AMENDMENT OF SOLICITATION/MODIFICATION OF CONTRACT				1. CONTRACT ID CODE J		PAGE 1 OF 8 PAGES	
2. AMENDMENT/MODIFICATION NUMBER 0001		3. EFFECTIVE DATE 01 MAY 2026		4. REQUISITION/PURCHASE REQUISITION NUMBER		5. PROJECT NUMBER (If applicable)	
6. ISSUED BY W071 ENDIST SEATTLE KO CONTRACTING DIVISION, 4735 EAST MARGINAL WAY SOUTH SEATTLE, WA 98134-2329 UNITED STATES BRANTLEY DOWELL, EMAIL: BRANTLEY.W.DOWELL@USACE.ARMY.MIL TELEPHONE: 2067646952		CODE W912DW		7. ADMINISTERED BY (If other than Item 6) SCD: PAS:		CODE	
8. NAME AND ADDRESS OF CONTRACTOR (Number, street, county, State and ZIP Code)				(X)		9A. AMENDMENT OF SOLICITATION NUMBER W912DW26QA032	
				(X)		9B. DATED (SEE ITEM 11) 06 MAR 2026	
				()		10A. MODIFICATION OF CONTRACT/ORDER NUMBER	
				()		10B. DATED (SEE ITEM 13)	
CODE		FACILITY CODE

1) Update the PWS to reflect the change in the requirement for turn-key service with the rental of equipment

Performance Work Statement

Albeni Falls Dam (AFD)
Water Weight & Water Pumping Equipment
Turnkey Service for Crane Load Testing
Oldtown, ID 83822

Image A, Drawing of Load Block (Following Page)

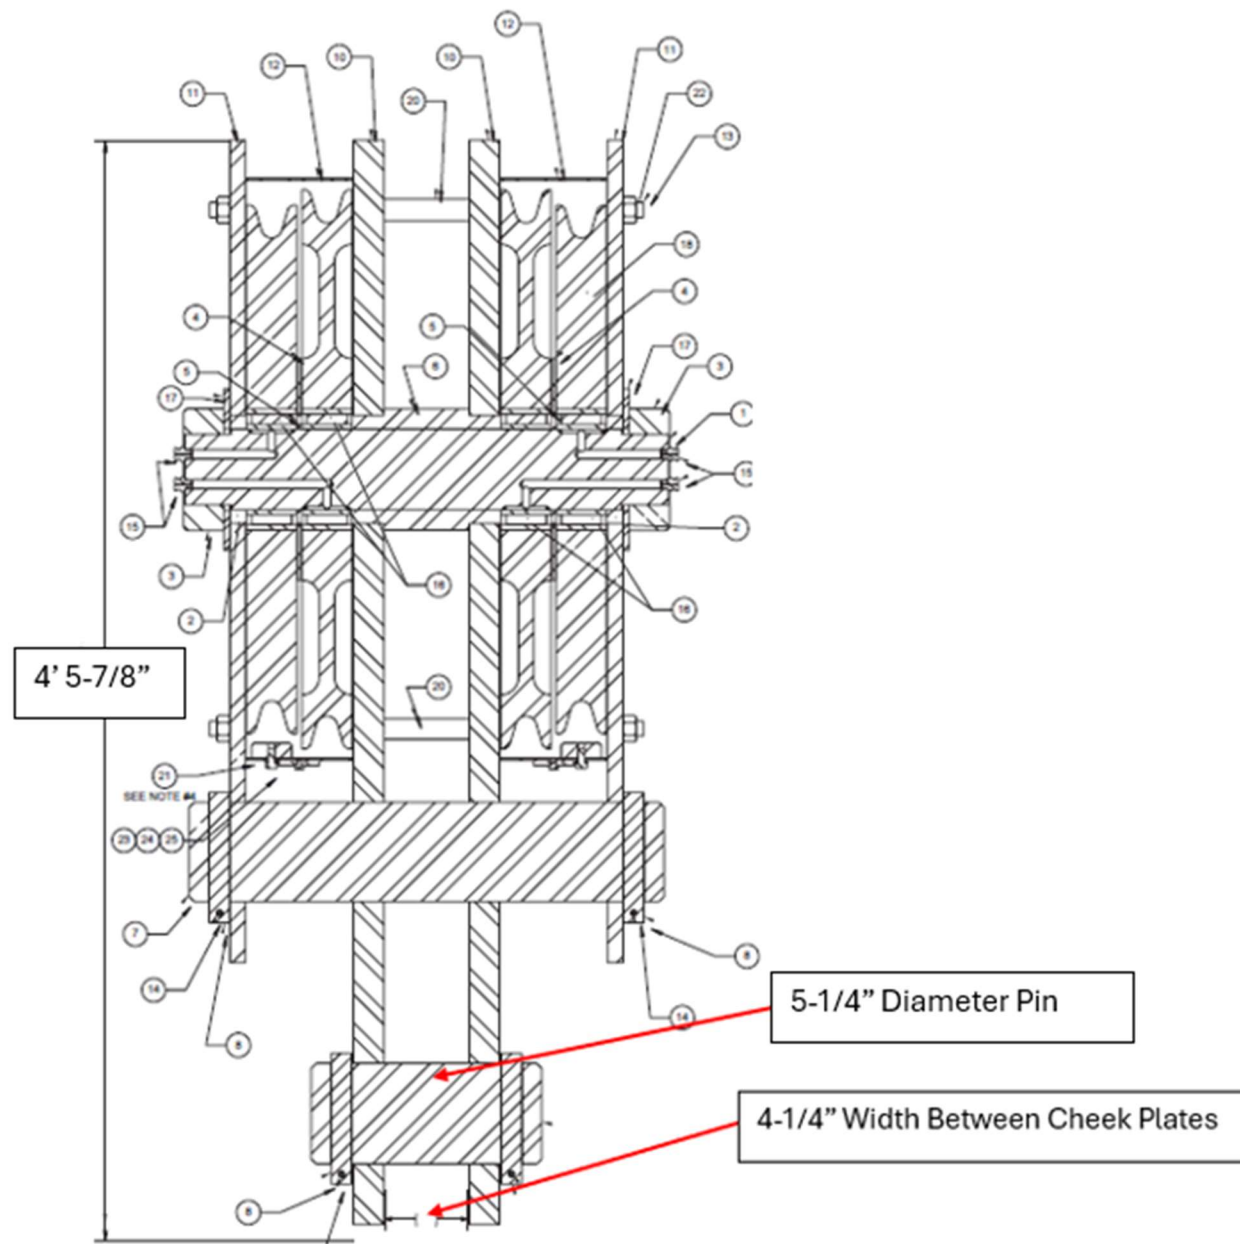
- a. Quantity: 2 **(or as needed)**
- b. Purpose: Connect shackles to Pins on crane load blocks. The load block pin is 5.25 inches in diameter, with 4.25" length between cheek plates. A drawing of the load block is provided in image A. Master links must fit over the load block pin. The load blocks do not have hooks.
- c. If the contractor can verify shackles will fit on crane load pins without master links, it is optional to not supply master links.
- d. Capacity: 85T WLL or greater.
